Change Order No. 1

Date of Issuance: 8/19/2025	Effective Date: 4/28/2025
Owner: City of Diamondhead	Owner's Contract No.:
Contractor: SCI, LLC	Contractor's Project No.:
Engineer: Chiniche Engineering & Surveying	Engineer's Project No.: 17-057-00-11-2023
Project: Coon Branch Drainage Improvements – Phase 1	Contract Name: Coon Branch Drainage Improvements – Phase 1

HEADWALL LOCACTION

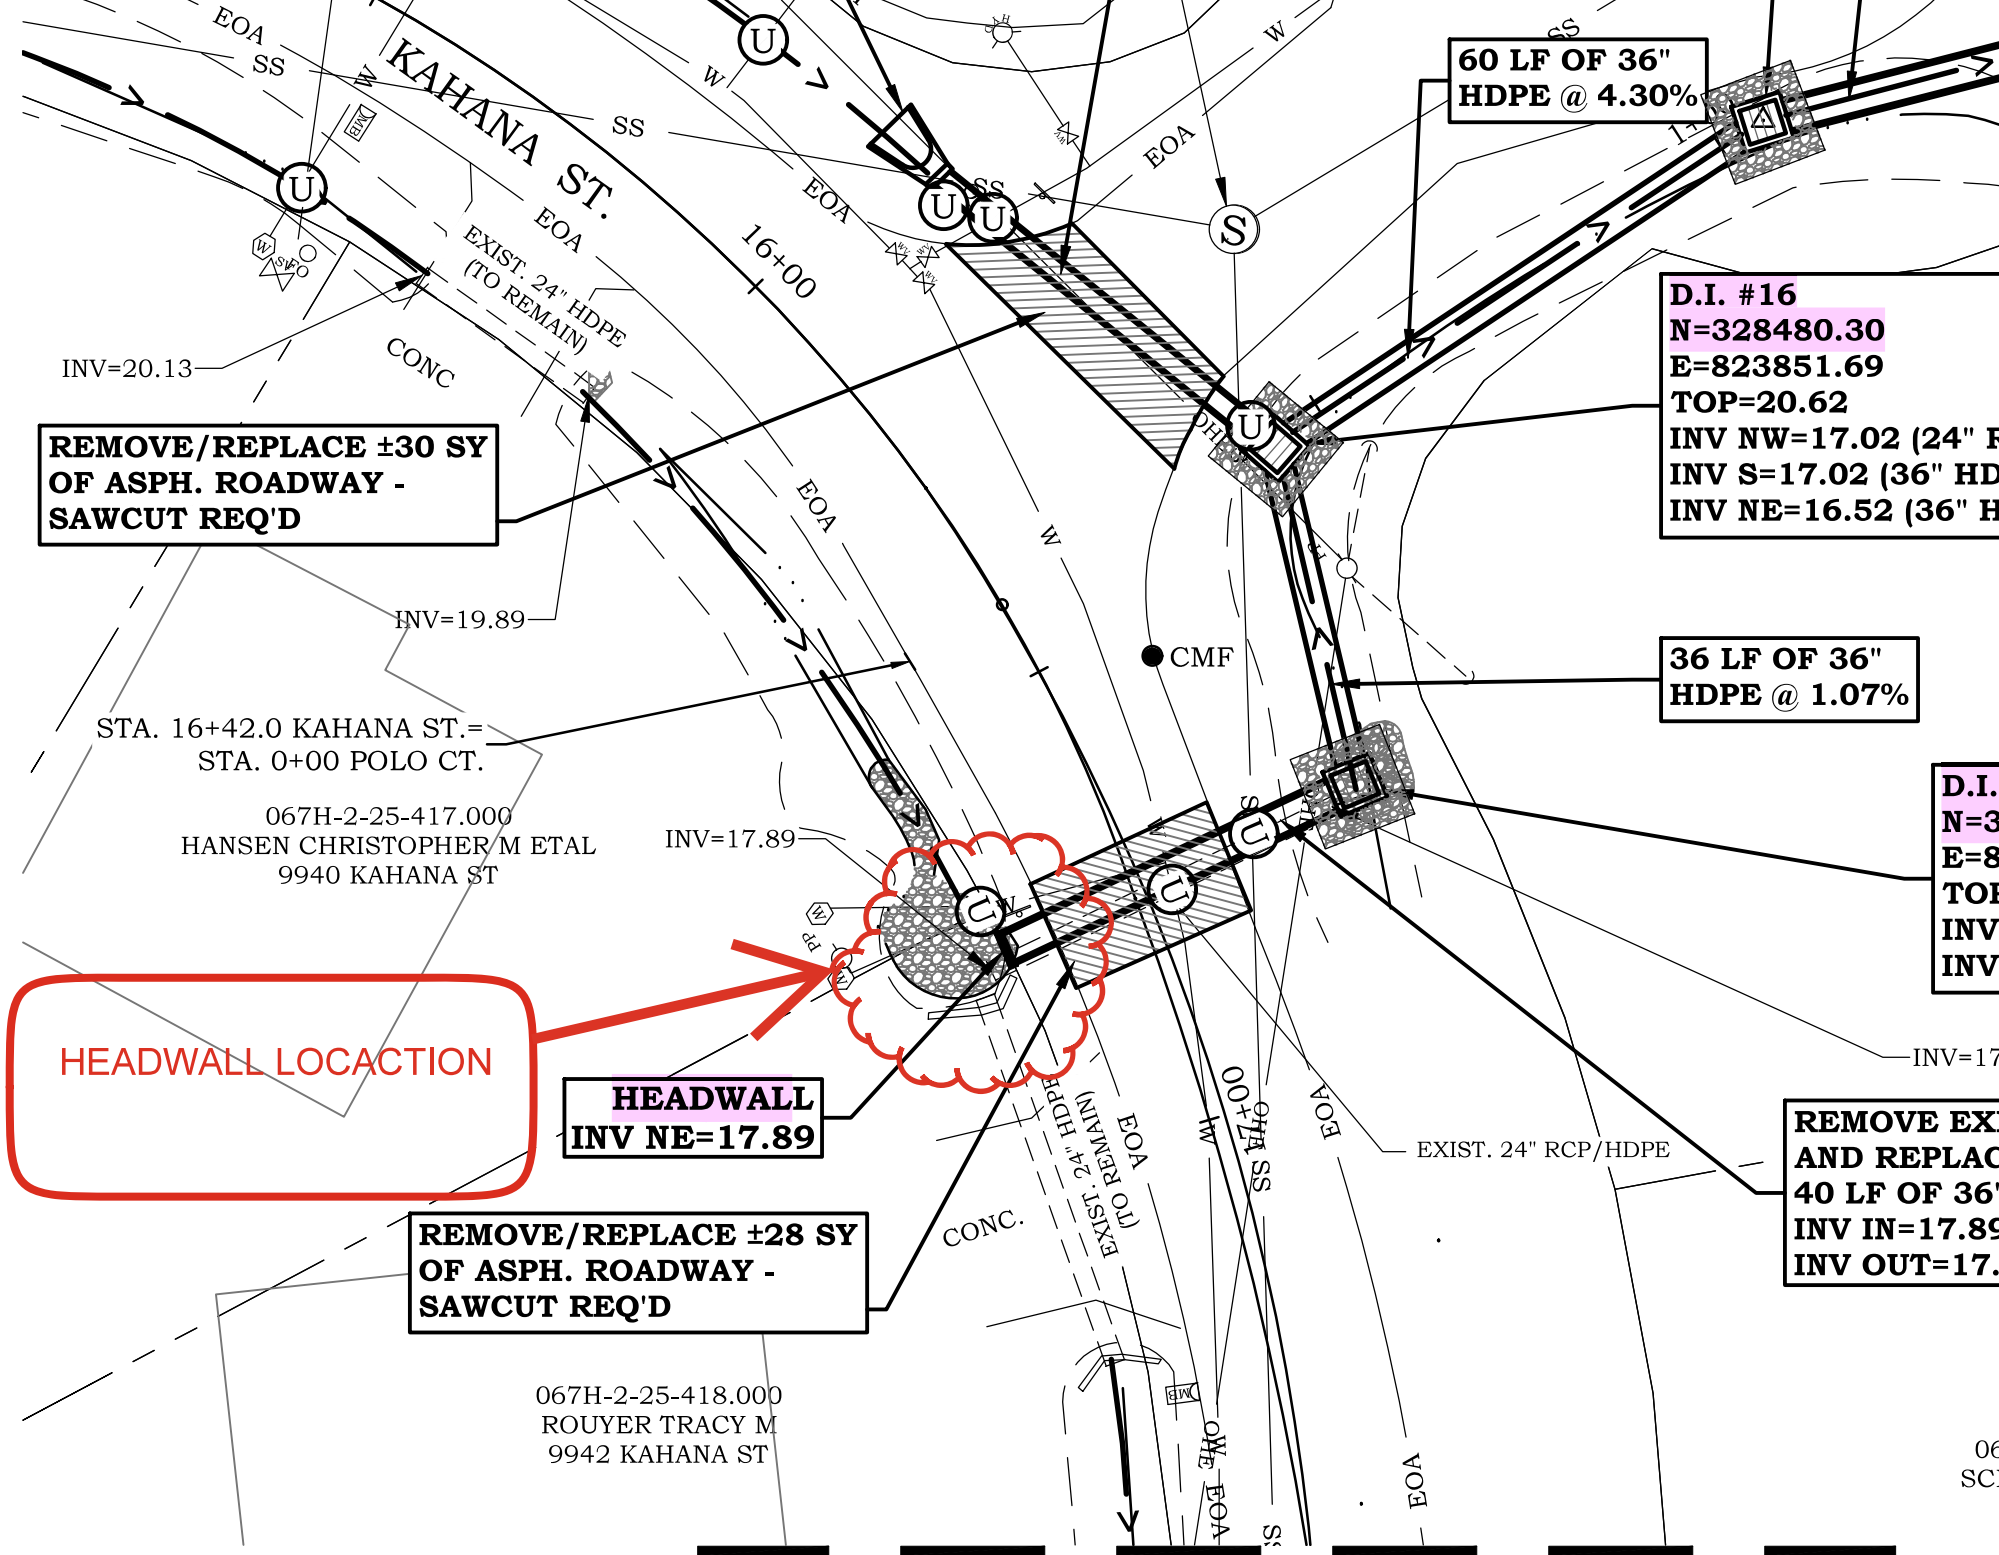
Description: The project includes the construction of a new headwall for the new 36" culvert across Kahana Street. The new headwall ties into the existing headwall for the driveway culvert located at 9942 Kahana Street. This existing headwall is in need of repair. The Contractor is proposing to remove the existing headwall and construct a double concrete headwall for both culverts.

NO.	DESCRIPTION	QTY	UNIT	UNIT PRICE	EXTENSION
02600 P	Concrete Headwall	-1	EA	\$ 6,250.00	\$ (6,250.00)
02600 P	CUSTOM Concrete Headwall	1	EA	\$ 15,625.00	\$ 15,625.00
				DIFFERENCE	\$ 9,375.00
